UNITED STATES PATENT AND TRADEMARK OFFICE

APPLICATION NO.	FILING DATE	FIRST NAMED INVENTOR	ATTORNEY DOCKET NO.	CONFIRMATION NO.
09/588,924	06/06/2000	Roger P. Jackson	00,063	9408

Office Action Summary

DETAILED ACTION***Claim Rejections - 35 USC § 102***

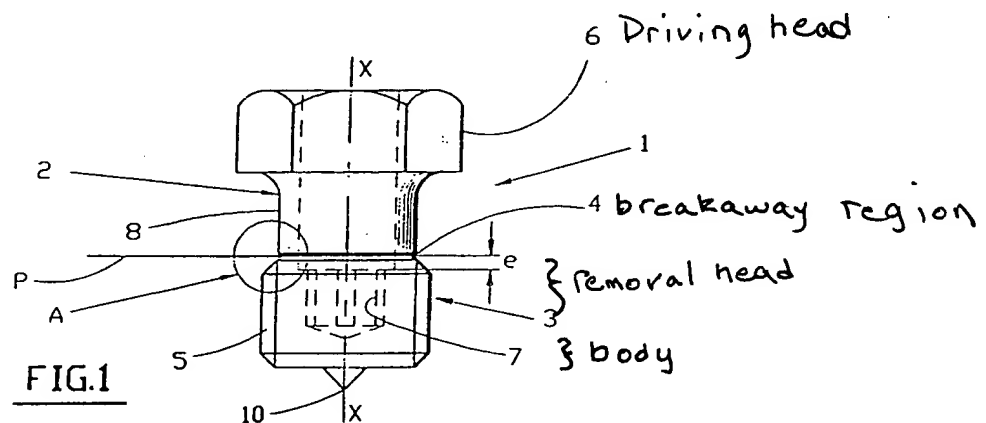
Regarding claims 1 and 9, Gournay discloses a "closure for use in conjunction with a medical implant having an inward threaded surface" (Fig. 1). See drawing below for an explanation of corresponding parts.

In this embodiment, Gournay does not illustrate an exterior/outwardly facing removal head. However, Gournay states, "In a general way, any type of print may be employed for the two component parts of the plug with, however, a preference for hexalobate prints. It is in this way possible to provide square, triangle, cruciform prints etc. for clamping and disassembly, *interior and exterior*, and any type of fracture initiating profile" (Col. 4, lines 46-51). Therefore, Gournay anticipates an exterior/outwardly facing removal head, even though the many possible combinations are not all illustrated in the drawings. In the alternative, it would have been obvious to one of ordinary skill in the art at the time the invention was made to make the removal head exterior/outwardly facing as a mere change in design in view of the aforesaid teaching.

The head is designed to break off at a predetermined torque (Col. 1, lines 47-51).

Regarding claim 2, the driving head 6 is joined to the closure body by a breakaway region 4. The breakaway region 4 breaks away when a preselected force is applied to the driving head 6 (Col. 1, lines 47-51 and Col. 2, lines 34-35).

Regarding claim 4, the driving head and the removal head have different shapes, which prevent the installation tool from inadvertently gripping the removal head 6. Gournay teaches that the shape of either the driving head or the removal head may be of any shape (Col. 4, lines 46-51).
